PCN#20230213000.0
Symbolization update for select TSSOP devices
Information Only

Date: February 14, 2023

PCN Number:	20230213000.0		PCN Date:	February 14, 2023
Title:	Symbolization update for select TSSOP devices			
Customer Contact:	PCN Manager	Dept:	Quality Services	
Change Type:				
☐ Assembly Site	☐ Assembly Process	☐ Assembly Materials		
☐ Design	☐ Datasheet	☐ Mechanical Specification		
☐ Test Site	☒ Packing/Shipping/Labeling	☐ Test Process		
☐ Wafer Bump Site	☐ Wafer Bump Material	☐ Wafer Bump Process		
☐ Wafer Fab Site	☐ Wafer Fab Materials	☐ Wafer Fab Process		
	☐ Part number change

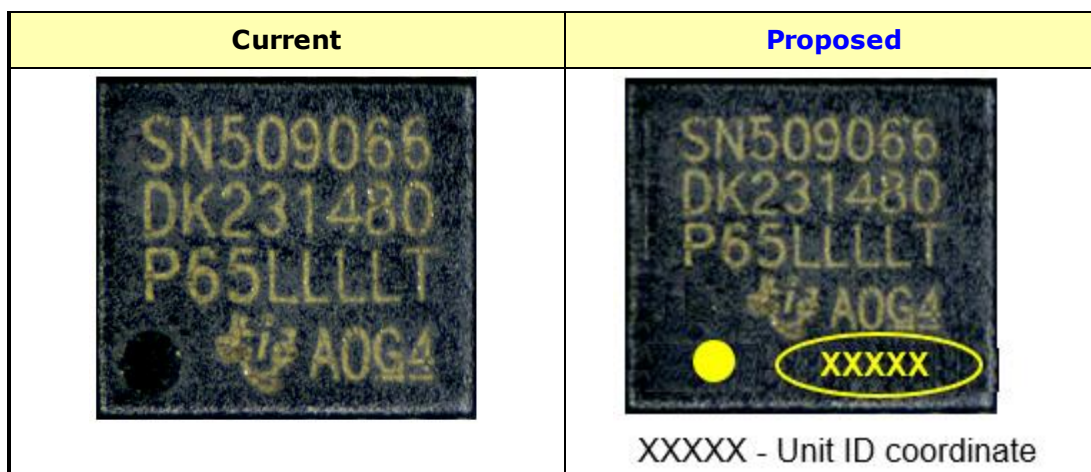
This letter is to inform customers of a device symbolization change for select devices in the TSSOP package that will enable enhanced device level traceability as follows:

Added device symbolization row
